Urgent Field Safety Notice

Action 3 Junior – Push bar finger bolts

Invacare Ref: FSN 035

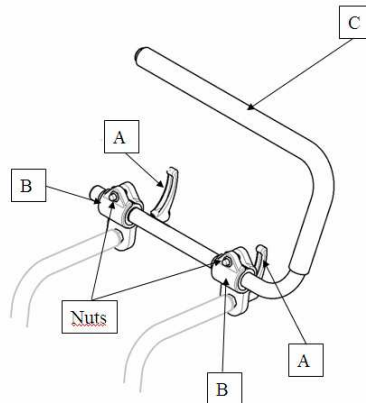
In the interests of the safety of our customers we would like to bring your attention to a potential failure of Action 3 Junior push bar M6x30 finger bolts (rep A).

The failure of finger bolts can lead to injuries if control of the chair is lost.

A modification has been implemented starting from the SN051021027909 (28th June 2010). The effectiveness of this solution has been confirmed by specific fatigue tests which are in accordance with ISO 7176 requirements.

Remove the parts on the chair

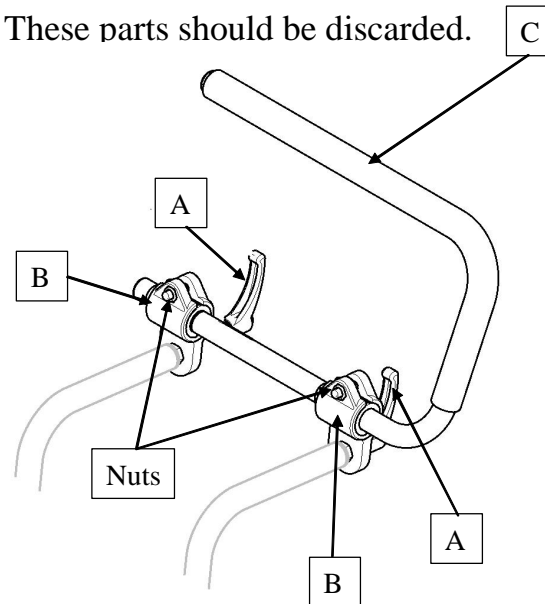
- Unscrew the both nuts of the plastic part and remove the original push bar (piece C) from the chair.
- Remove the Handles M6 (pieces A) – These parts should be discarded.
- Remove the Plastic parts (pieces B) – These parts should be discarded.

Assemble the new parts provided with the kit, on the chair.

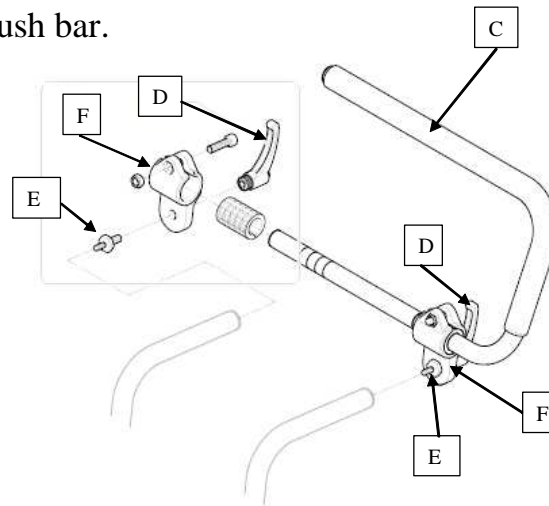
- Fit the M6/M8 Adaptor using 17mm spanner (pieces E) – torque 10Nm.
- Assemble the Plastic parts (Pieces F).
- Screw the Handles (pieces D).
- Replace the original Push bar (piece C).
- Tighten Handles (D) to secure Push bar.
